Block(s): 16 & 17 Section: 13 District/Division: MAWSON

Issue	Date	Amendment
Project		
Multi Unit Housing		
Site		
blocks 16+17		
section 13,		
Mawson, ACT.		
Title		
Site Plan		
Scale	1:200	Drawn By SA
Date	May 2008	Drawing No. 1284 - A
PETER BYFIELD + Associates Suits A, 34 Taylor Street, Ainsworth NSW 2158 Phone 02 9880 2255 Fax 02 9660 2255

Title
Floor Plans Units 1-5

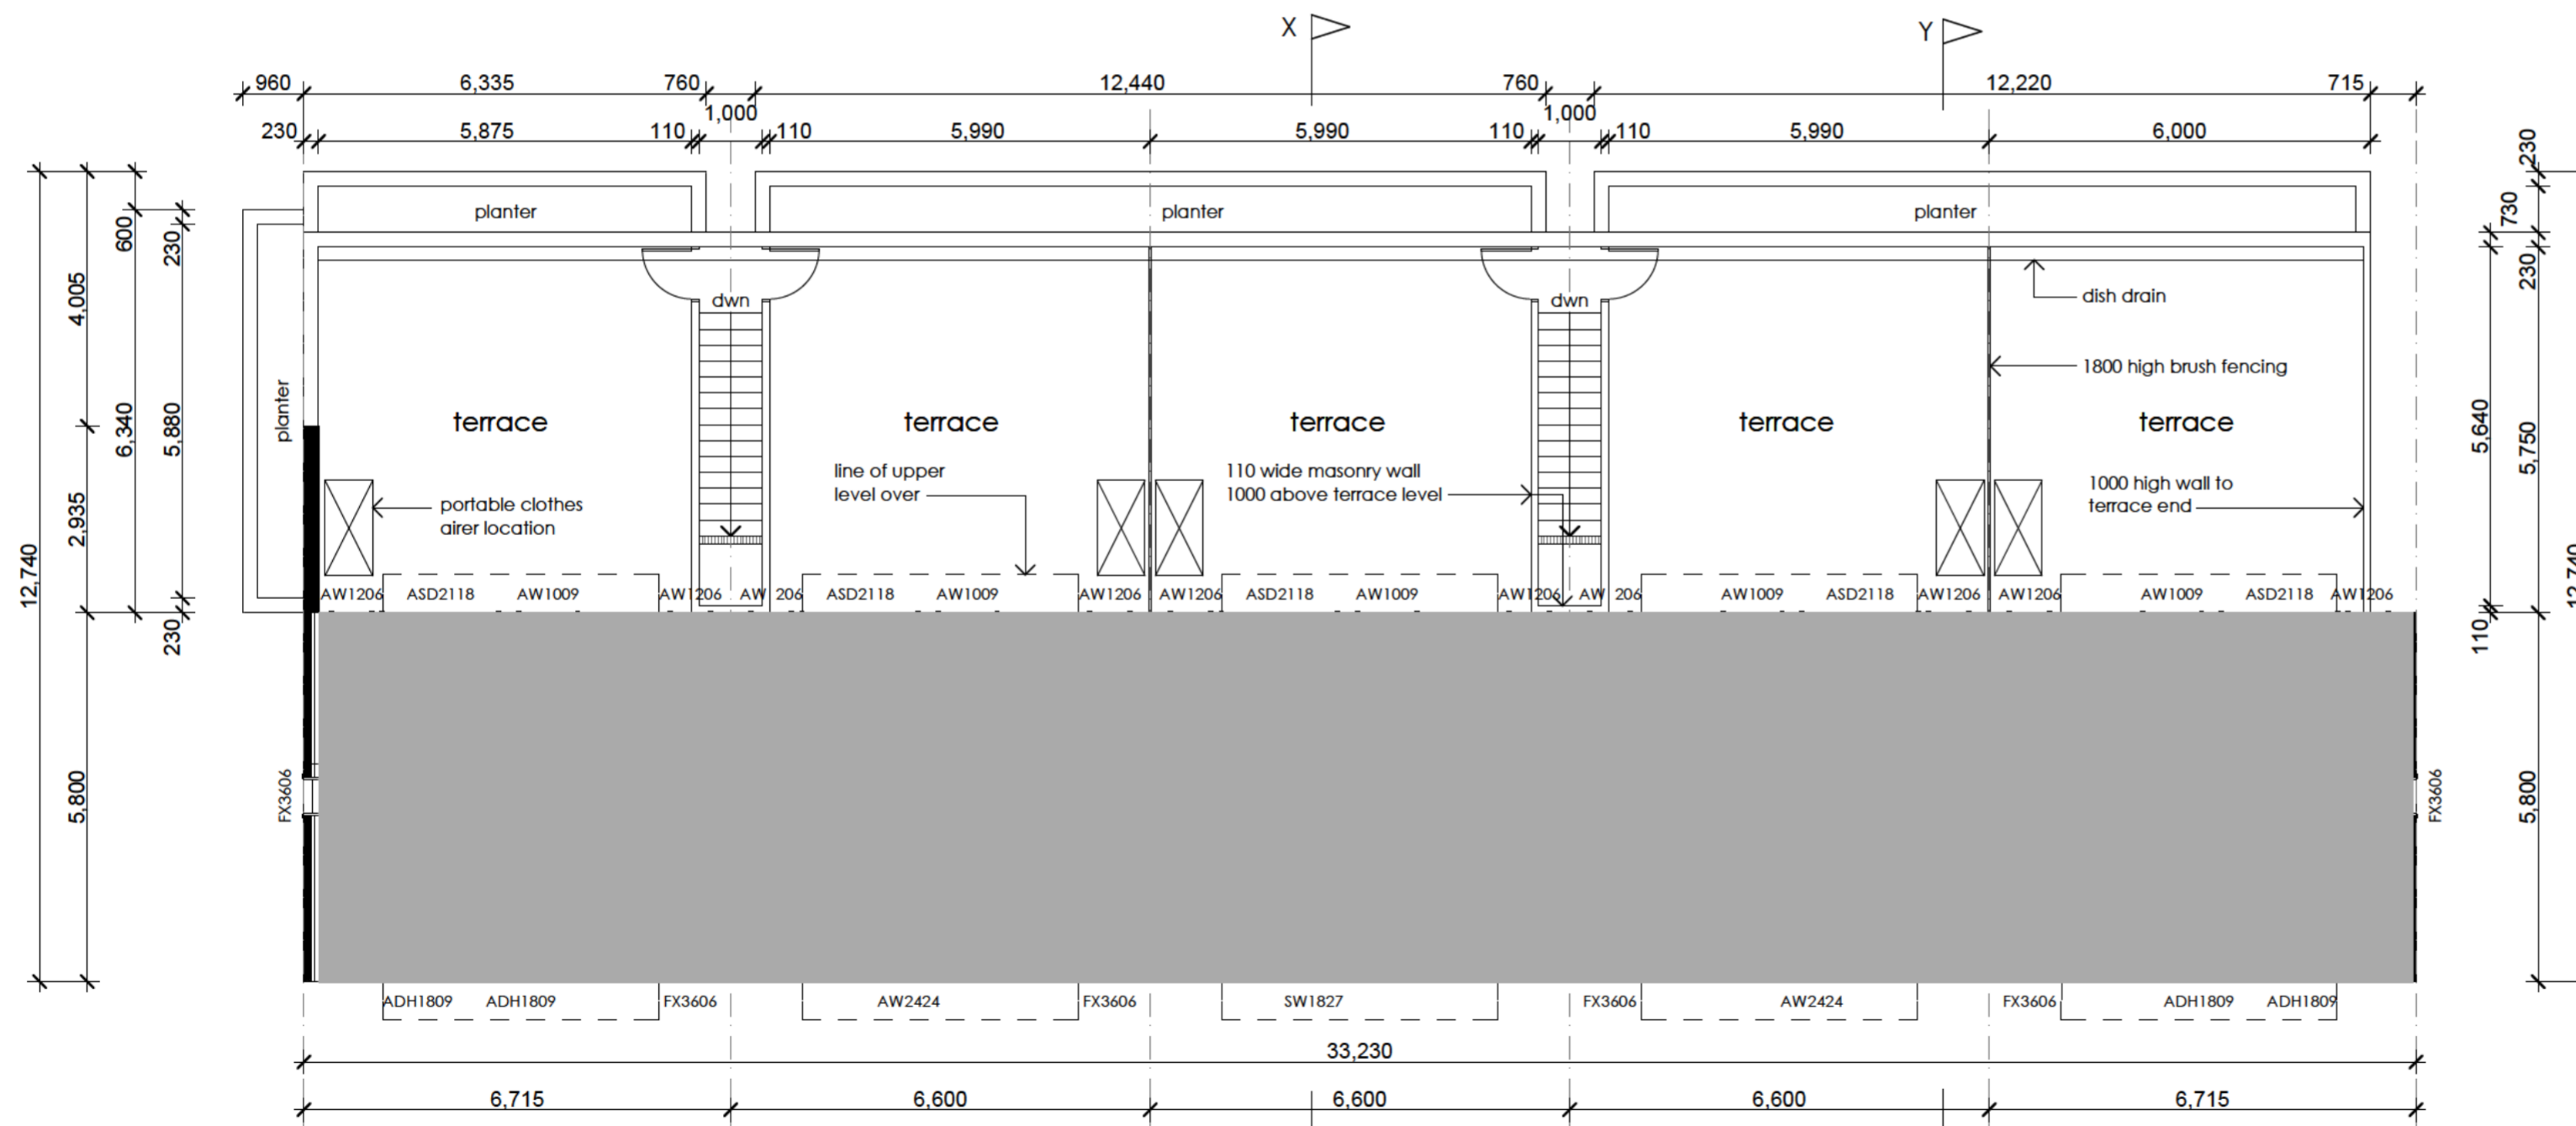
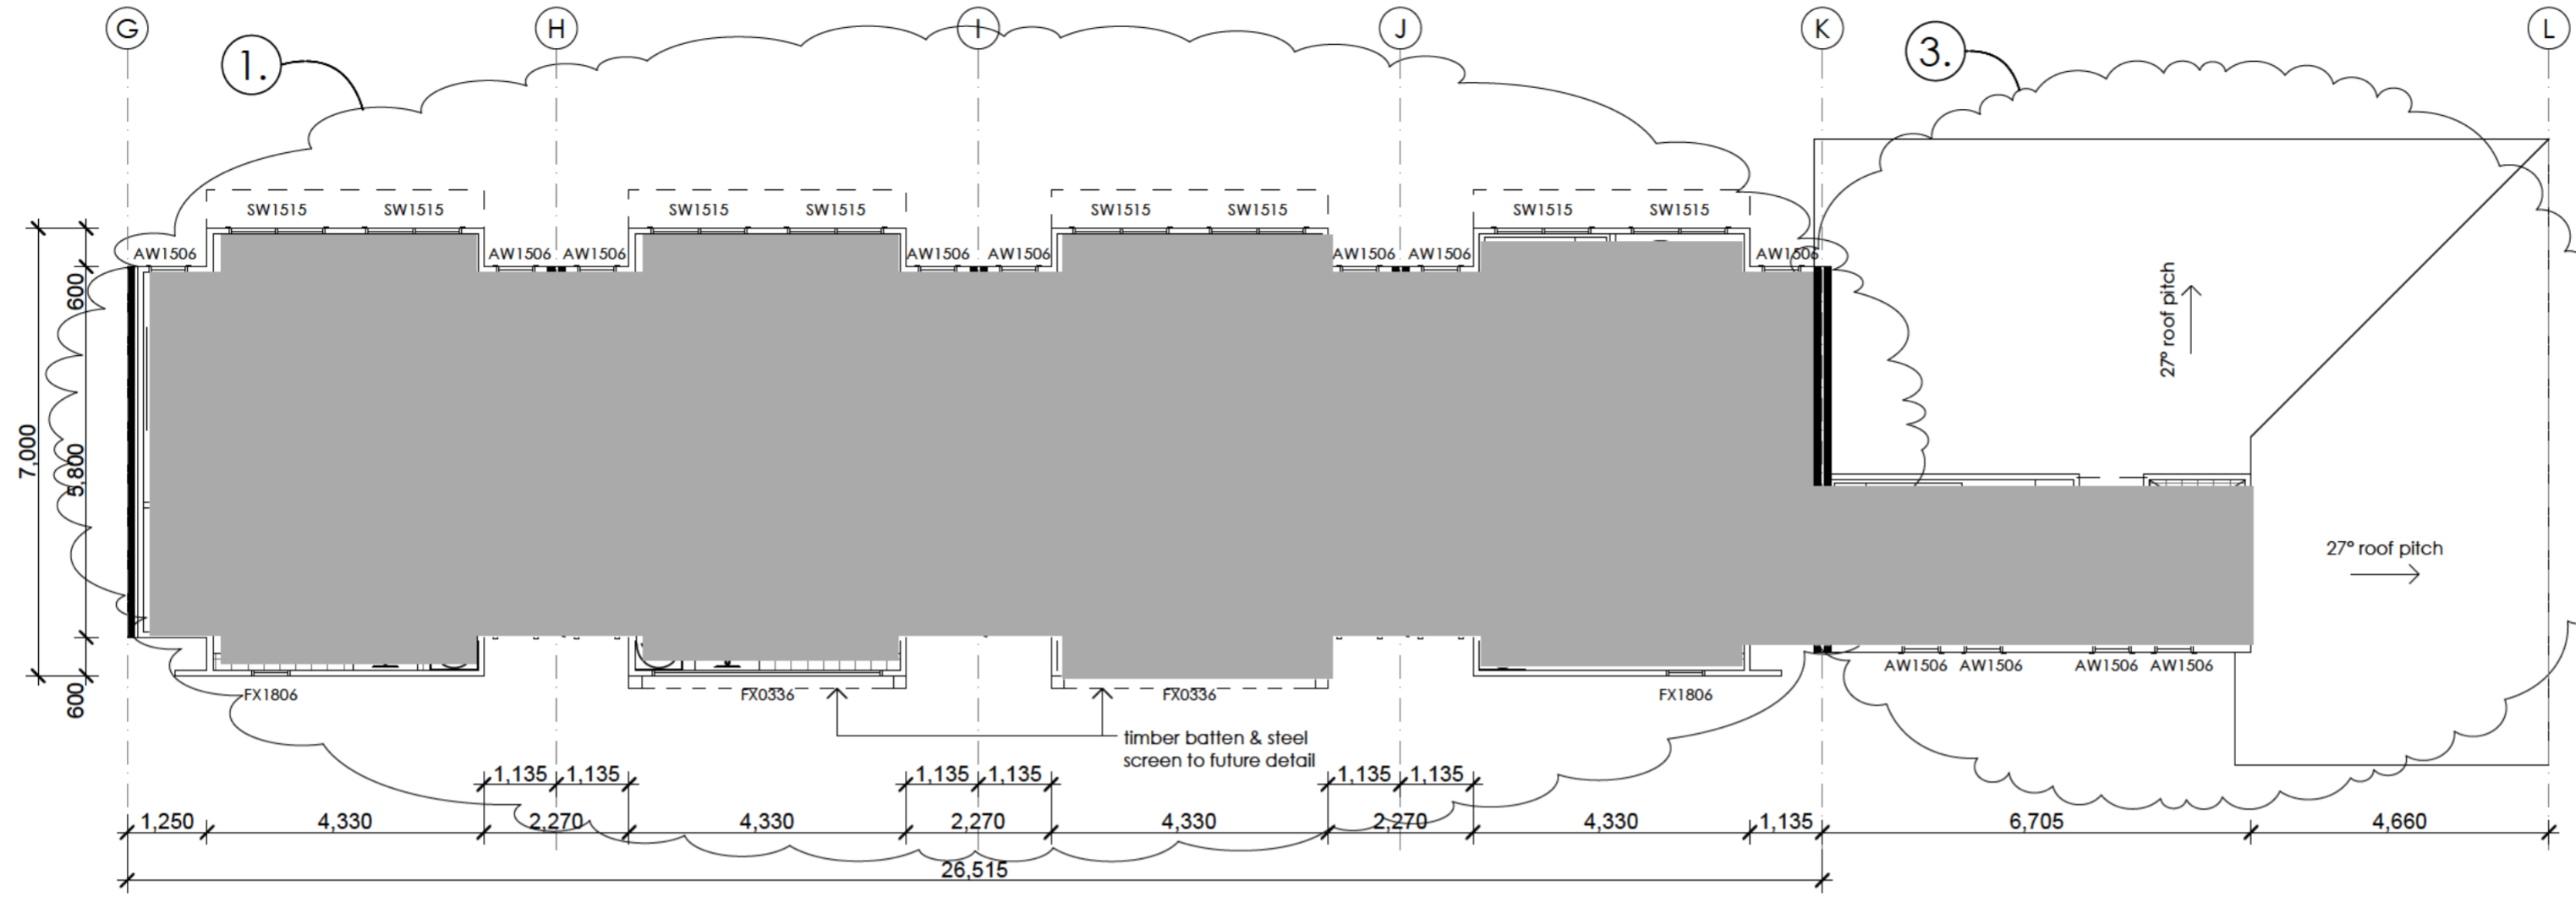
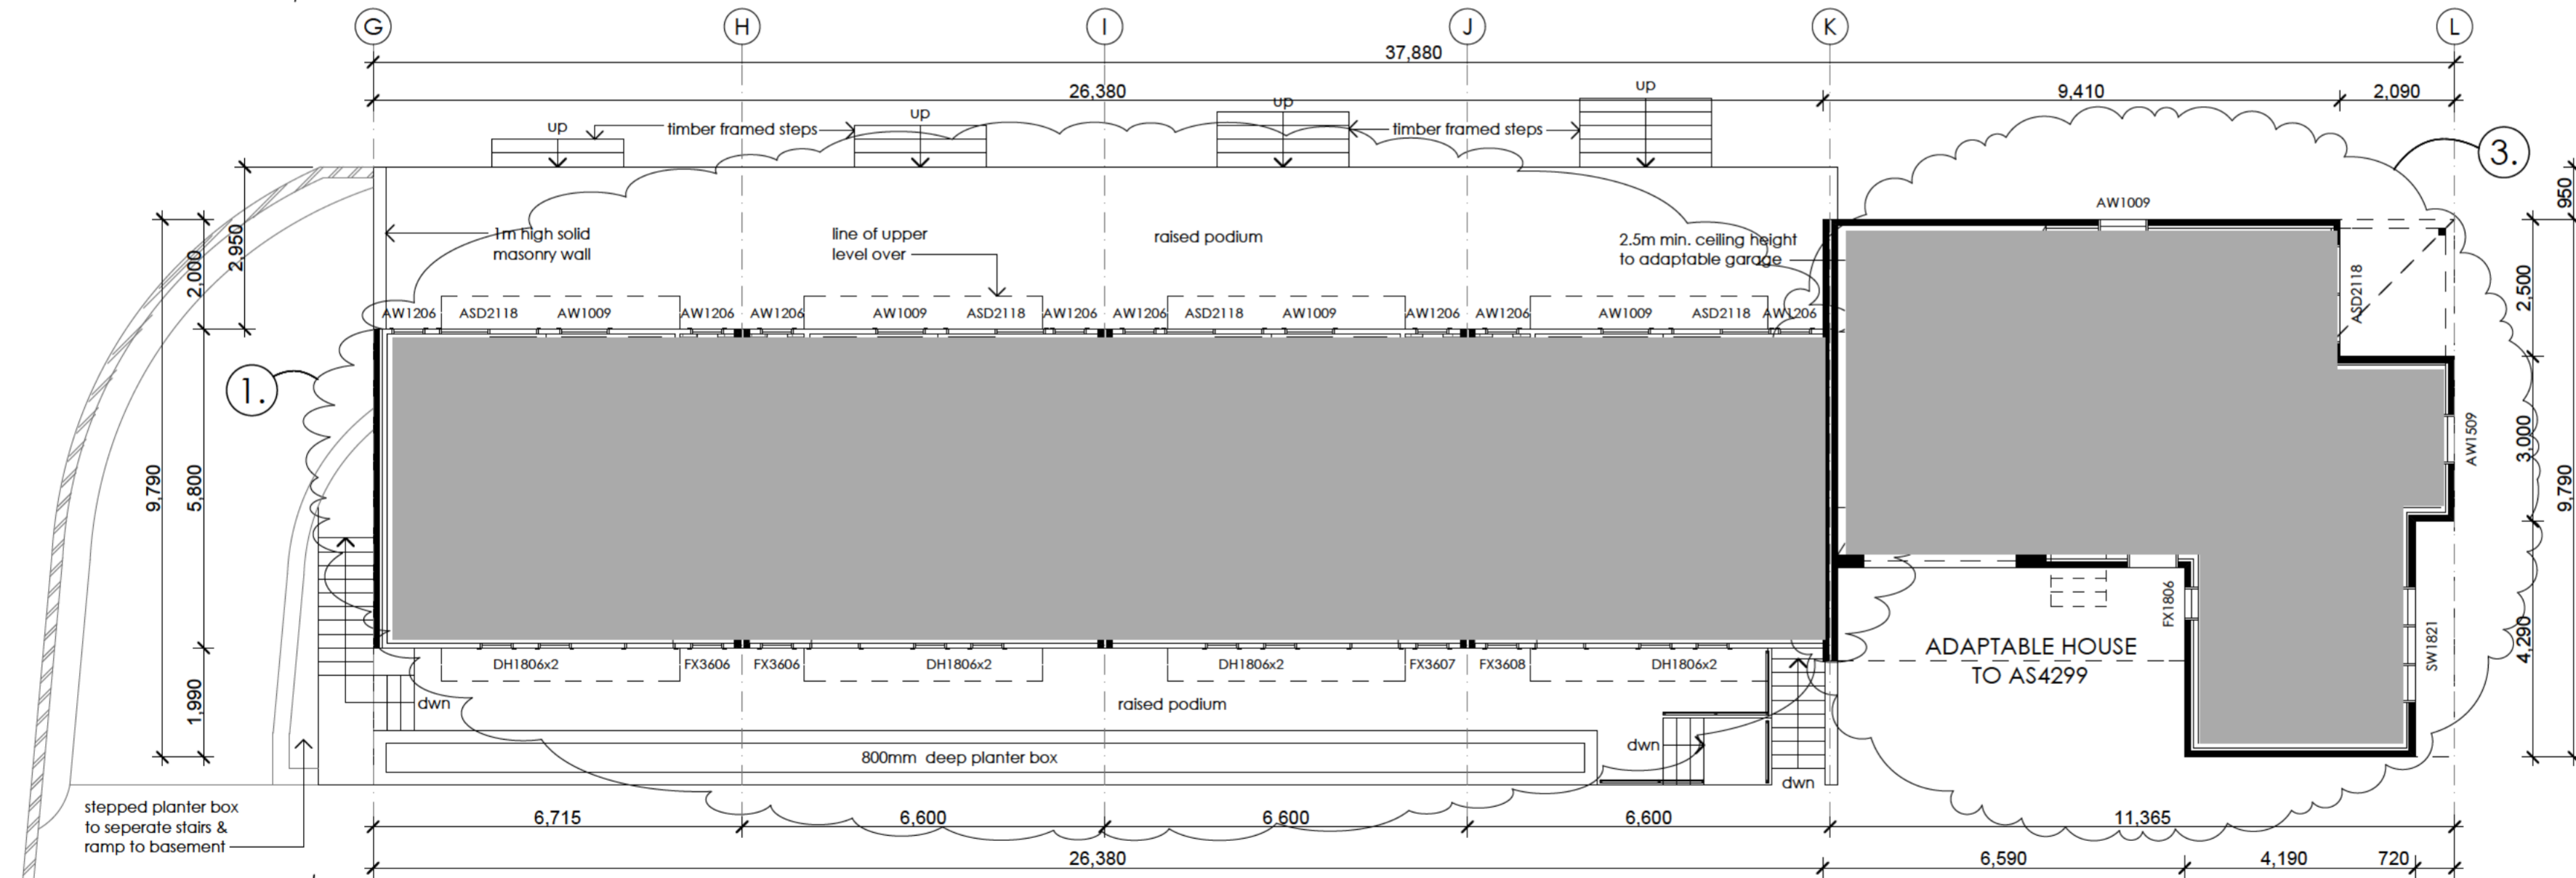
UNIT 1 AREAS	UNIT 2 AREAS	UNIT 3 AREAS	UNIT 4 AREAS	UNIT 5 AREAS
ground level living 38.9m ²	ground level living 38.2m ²	ground level living 38.2m ²	ground level living 38.2m ²	ground level living 38.9m ²
upper level living 39.1m ²	upper level living 38.4m ²	upper level living 38.4m ²	upper level living 38.4m ²	upper level living 39.1m ²
terrace 36.9m ²	terrace 36.2m ²	terrace 36.2m ²	terrace 36.2m ²	terrace 36.0m ²
garage 38.7m ²	garage 38.0m ²	garage 38.0m ²	garage 38.0m ²	garage 19.6m ²
Total 153.6m²	Total 150.8m²	Total 150.8m²	Total 150.8m²	Total 133.6m²

- Provide enclosure for units 6-9 waste bins.
- | Issue | Date | Event |
